Aircraft Design Certification GmbH Reichensteinstr.48 69151 Neckargemünd		Elevator and tab deflections, gurney flap	Doc-Nr: ADxC-73-SB-039 Issue: A Date: 23.11.2023 Change Nr.: DC-074
Service Bulletin Bristell B23

Elevator and tab deflections, gurney flap
SERVICE BULLETIN BRISTELL B23

As production feedback it was requested to increase the tolerances for setting the elevator down deflection and trim tab (trim/ anti-servo tab) deflections. A design change is performed demonstrating larger acceptable tolerances which are published in respective maintenance manual.

Explanations:

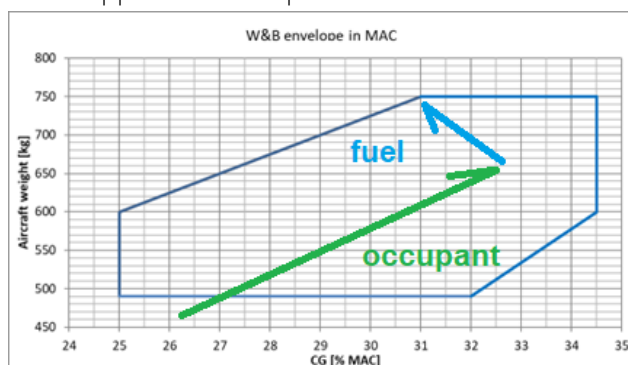
- Elevator:
 - o DOWN deflection and tolerance originally was $15^{\circ} \pm 2^{\circ}$ resulting in an acceptable range of -13° to -17° .
 - o The changed range is -11° to -17° .

- This is published in the ADxC-73-001-AMM Edition 2.2 section 20-50-01.
 - o The UP deflection is not affected by the change.
 - Its correct setting features relative tight tolerance of $19^{\circ} \pm 1^{\circ}$ which is bracketed on one side by control needs (min 18°) and post stall departure characteristics (max 20°).

- Tab
 - o The tab on the elevator co-acts as trim and as anti-servo tab.
 - o Its gearing relevant for the longitudinal stability.
 - Checking the gearing is described in ADxC-73-001-AMM Edition 2.2 20-60-01.

- o Its deflection range, with elevator not moving, is relevant for the trim range
 - Critical is the low speed, flap down, idle situation where nose UP trim is required.

- Gurney flap:
 - o The optional gurney flap improves the low speed trim point on cost of high speed trim point.
 - o Due to its detail location it has more influence on the (critical) power-off trim range than on the power-on trim.

- o The gurney flap mounts to the rearmost end of the tab and therefore is relevant with respect to tab and elevator static moment. The result of the addition must be checked against limits according ADxC-73-AMM-001 section 51-60. Update airplane life cycle documents accordingly.
